ZM497 AND ZM1497

**NEW SUITABILITY WITH VALEO 594449 AND
ADAPTABLE TO STARTERS D6RA110**

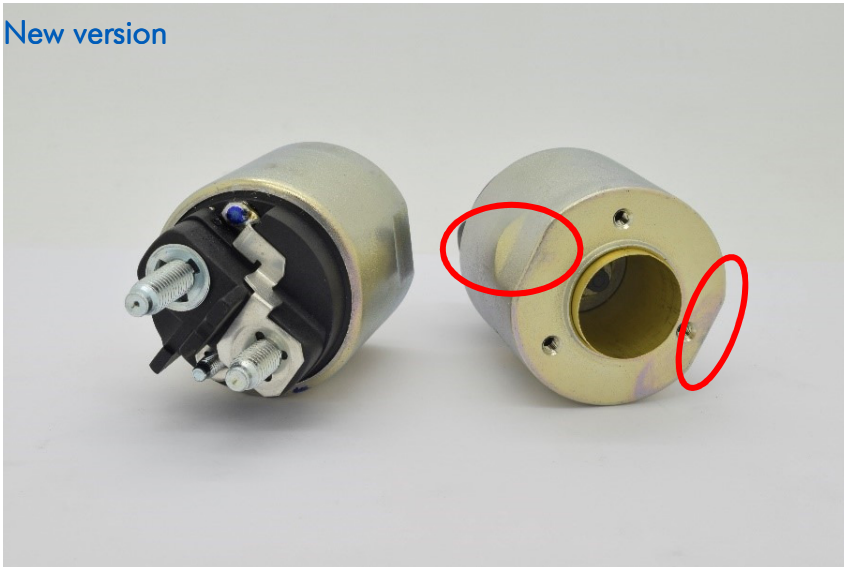
Our Supplier ZM, during range improvement, has changed the solenoid [ZM497](#) drawing.

The most visible change (red circles) is the double facet on the body in order to get easy the placement on the specific starter bracket.

The main goal was enlarge the application list to starter Valeo [D6RA110](#), without open new project.

The result has been obtained with two versions:

- [497](#), solenoid without plunger
- [1497](#), solenoid with plunger
